Title: Advisory Committee on Reactor Safeguards
Reliability and PRA Subcommittee

Date: Wednesday, May 7, 2003

THE INDUSTRY TRENDS PROGRAM AND

PERFORMANCE INDICATORS

1. Regulatory Uses and Actions

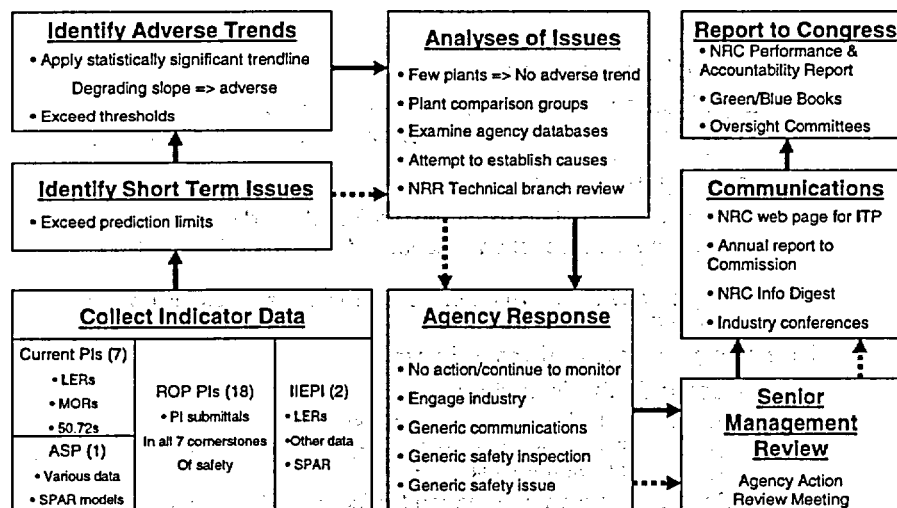
- Comments
 - Develop more concrete examples of regulatory actions
- Response
 - Developed a flowchart of the ITP process
 - Refined the two-tier process for the ITP
 - Integrated indicator with thresholds
 - Individual IE trends and predictive distributions
 - Developed some example scenarios and potential NRC actions

Figure 1-1 Industry Trends Program process flowchart

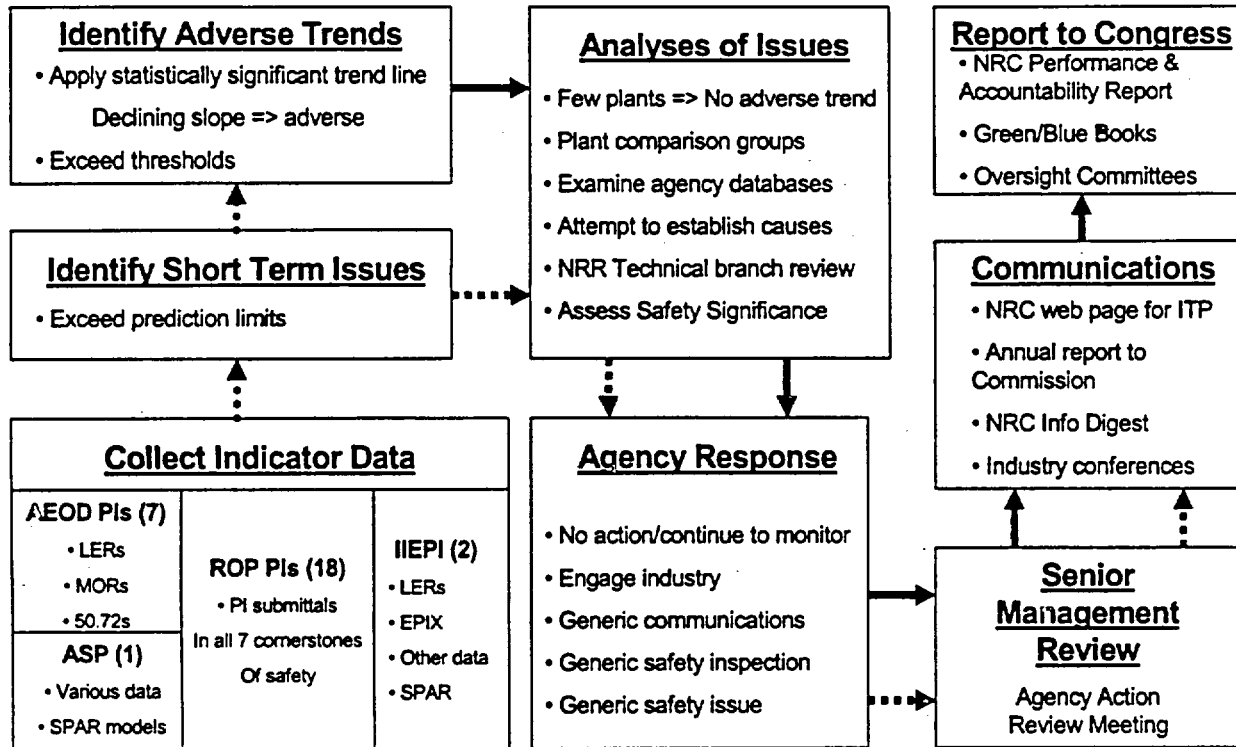
7 MR. LEITCH: Tom, a question before you
8 leave. In the paper that was distributed it lists
9 three main objectives of the Industry Trends Program,
10 and one of those says collect and monitor industry-
11 wide data, so that it can be used in a number of
12 things, but it also says to provide feedback for the
13 ROP. Is there a feedback to the ROP that's not shown
14 on this chart or am I misinterpreting what I'm reading
15 here? I don't quite understand how that feedback to
16 the ROP occurs.

17 MR. BOYCE: Now, you're correct. One of
18 the purposes to provide feedback to the ROP, it's not
19 shown on this process, this process is actually
20 focused on what do we do if we have an adverse trend.
21 You could say that if we take the appropriate agency
22 response, we would be -- that agency response
23 typically comes in the form of additional inspections.
24 And so you could say that that was feedback to the
25 ROP.

1 I guess that's only half of it. The other
2 half, which is not shown, is we're developing lower,
3 and you'll hear more about this, additional
4 indicators, say at the component level, where we're
5 trying to say "Give news you can use to individual
6 inspectors," that they might be able to compare how
7 their plant is doing against an industry average.
8 That is a future type development effort. I think we
9 discussed it a little bit in the paper, but we're also
10 doing it in response to Davis-Besse Lessons Learned
11 Task Force recommendations to improve our handling of
12 operating experience.

13 So I guess the short answer is only have
14 of what we're doing for feedback for the ROP is
15 illustrated in this flowchart. Is that --
